Addendum No. 7 to the EIR

San Bernardino County Transportation Authority |
Redlands Passenger Rail Project

SCH No. 2012041012

January 30, 2019

Figure 3. Twin Creek Side Drain Connection: Revised Footprint

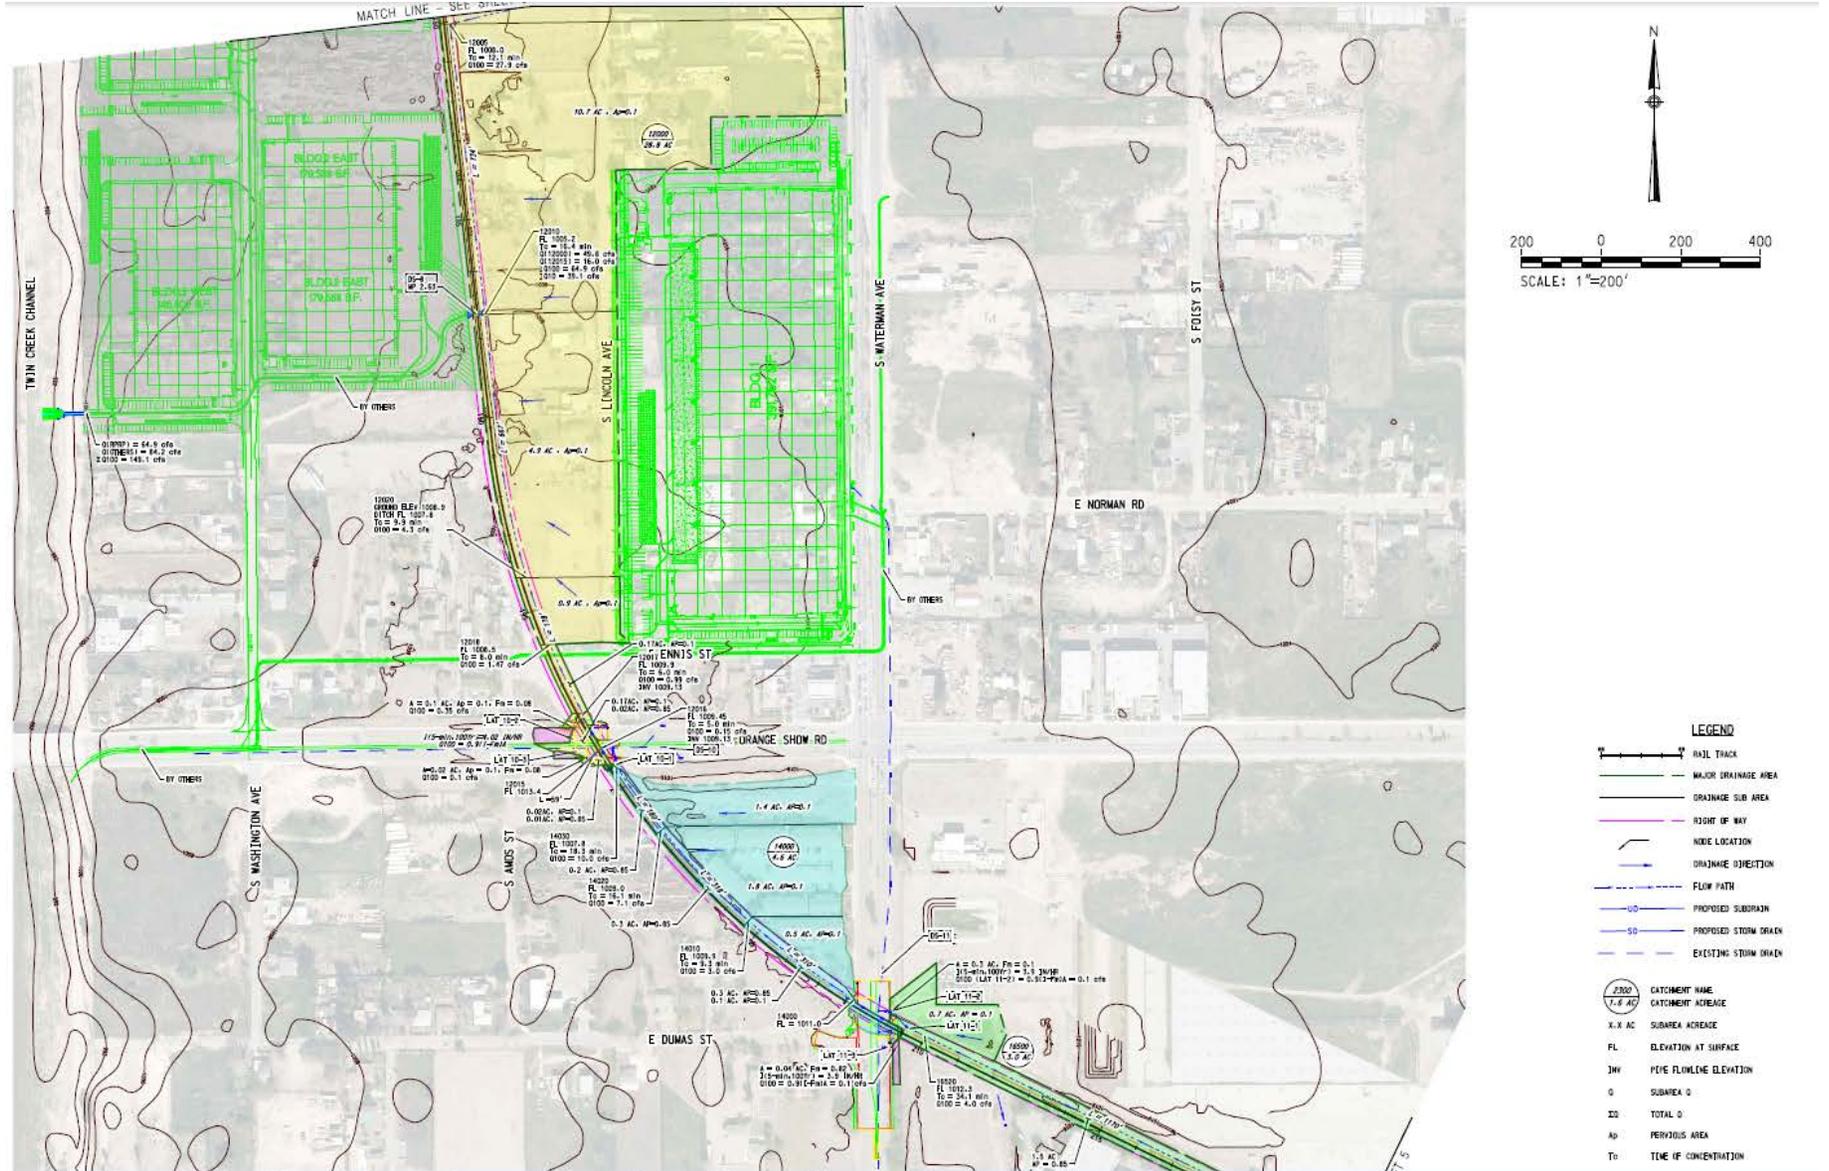
Side-Drain Connection (DS-9A): SBCTA is proposing the installation of a new side-drain connection at the western end of the storm drain system contemplated for the Washington Commerce Center East and West projects prior to the confluence with Twin Creek. The storm drain system would be connected to the proposed side-drain connection through three, 36 inch reinforced concrete pipes (RCP). The RCPs would extend 91.88 linear feet (LF) underneath an access road located on the eastern bank of Twin Creek at a slope of 0.003. The RCPs would discharge into the Twin Creek Channel at a 45 degree angle downstream. A new headwall with wingwalls would be constructed immediately after the RCP. One-fourth ton concreted rock slope protection would be installed at the outlet of the RCP and embedded into the channel slope to minimize the potential for scour. The limits of grading would extend approximately 47 linear feet after the RSP. Twin Creek is an Army Corps of Engineers (USACE) constructed facility, which is maintained and operated by the San Bernardino County Flood Control District. As a result, the proposed side drain connection is subject to the USACE's authorization under the Rivers and Harbors Act.

Discussion: The refined Project under Refinement 3 would relocate the Twin Creek side drain connection approximately 300 feet south of the previously contemplated side drain connection as considered in Addendum No. 3. This analysis below considers the effects to existing hydrology and channel hydraulics based on the revised design, which include input from the local flood control district and the U. S. Army Corps of Engineers (USACE).
